GOVERNMENT OF THE DISTRICT OF COLUMBIA
DEPARTMENT OF TRANSPORTATION

Memorandum

SUBJECT: ZC Case 11-08 (Application of Il Palazzo LLC; 2700 16th Street, N.W.)

Picture 1 – Intersection of 16th and Fuller Streets, NW. Circular driveway of subject property (2700 16th Street, N.W.). Existing curb cuts do not meet DDOT Design & Engineering guidelines.

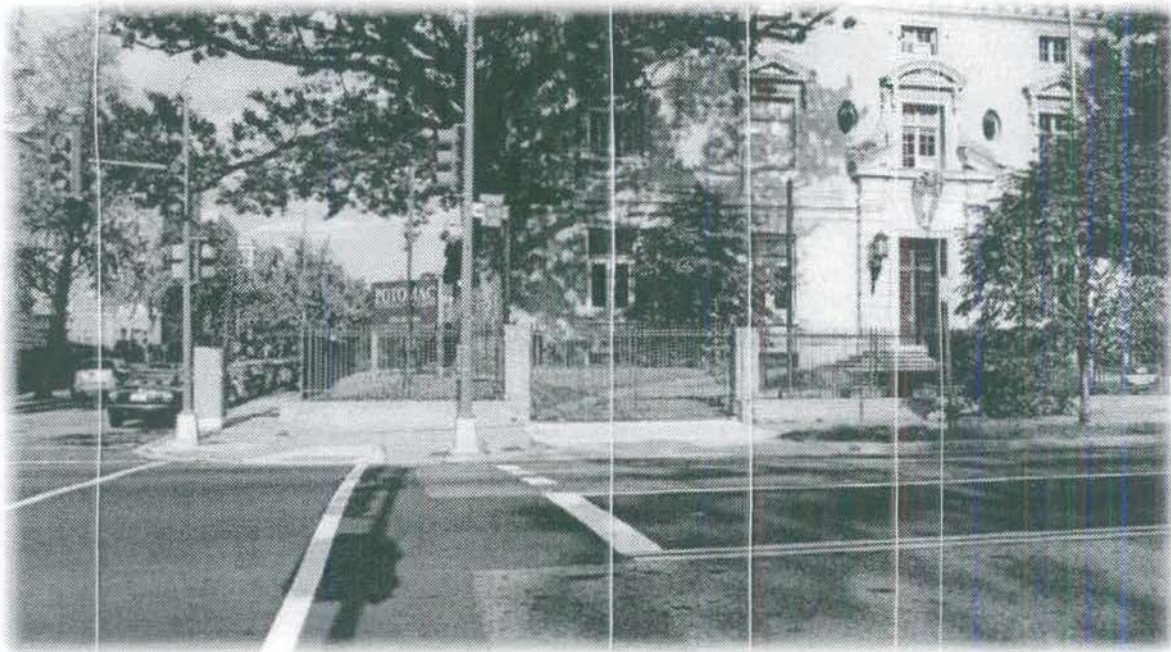
There are two (2) existing curb cuts located in front of the subject property, on 16th Street. The Applicant proposes to re-use the existing curb cuts for passenger pick-up and drop-off. There is additional interest to maintain the circular driveway curb cuts because the Applicant believes the future residents will have groceries and parcel packages delivered to this area of the property. The requested curb cuts on 16th Street, N.W. of the proposal do not meet the DDOT Traffic Safety Division requirements which state, *"No driveway of any entrance or exit to an intersection shall be closer than 60 feet to a street intersection as measured from the intersection of the curb lines extended. On the approach direction to an intersection the driveway edge line must be located a minimum of 60 feet from the point of intersection of two streets."* The 16th Street curb cuts are located less than 60 feet away from the 16th Street / Fuller Street intersection.

Photograph 3 – Parking and loading to Scottish Rite Temple on Mozart Street. Scottish Rite Temple, adjacent property to the subject address, has two curb cuts. Photograph shows one of the trees that would be affected by proposed curb cut to Applicant's property.

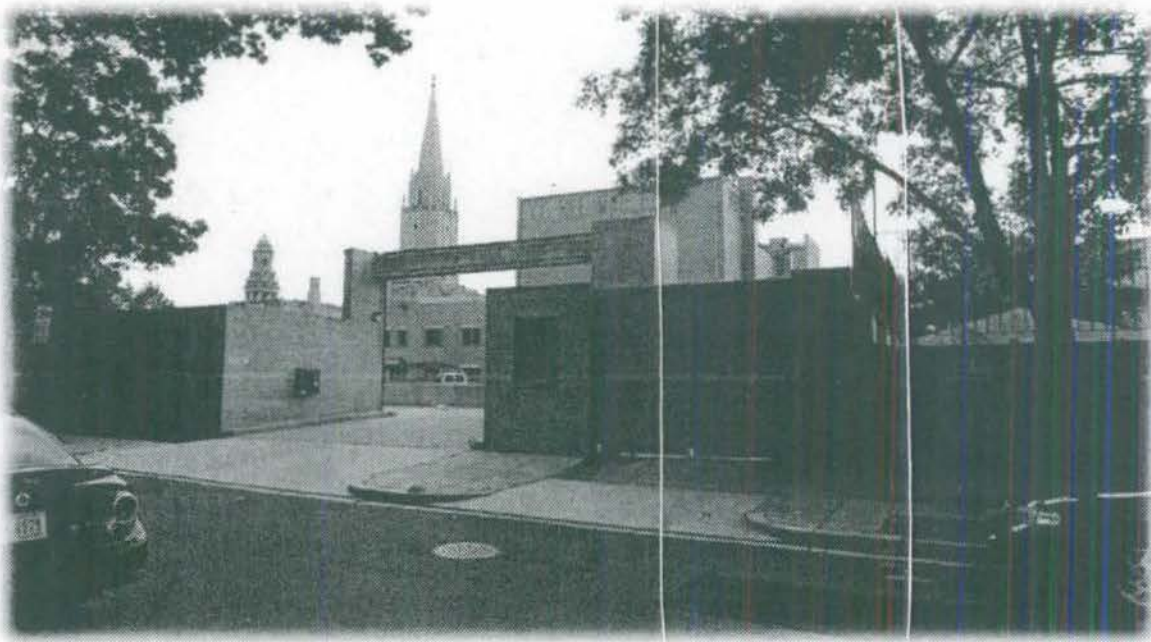
The Applicant's proposed Mozart Place curb cut poses a number of transportation and public space challenges. Mozart Place is a narrow one-way local street in the Adams Morgan neighborhood. DDOT staff measured the length of the existing curb cut driveways on Mozart Place and these driveways total (48) feet of public space. The Applicant is proposing a twenty six (26) foot driveway on Mozart Place to accommodate vehicles exiting from the subject property. This means there will be a total of 72 feet of private curb cut space on Mozart Place which would account for approximately one third of the residential block. The significant allowance of public space does not align with the City's use of public space.

The proposed driveway will further reduce the Adams Morgan curbside parking inventory by approximately four (4) vehicles. Based on the proposed plans, the Applicant's Mozart Place driveway warrants the removal of three (3) healthy street trees.

DDOT has encouraged the Applicant to further investigate widening the Fuller Street curb cut as an option to remedy the noted public space concerns associated with Mozart Place and 16th Street. Presently, there is a fifteen foot curb cut associated with the subject property. Vehicle access to the property can occur from Fuller Street and DDOT has agreed that widening the existing Fuller Street curb cut would allow for personal passenger vehicles and commercial vehicles to use it. Furthermore, the Applicant would not need to remove any street trees from Fuller Street.
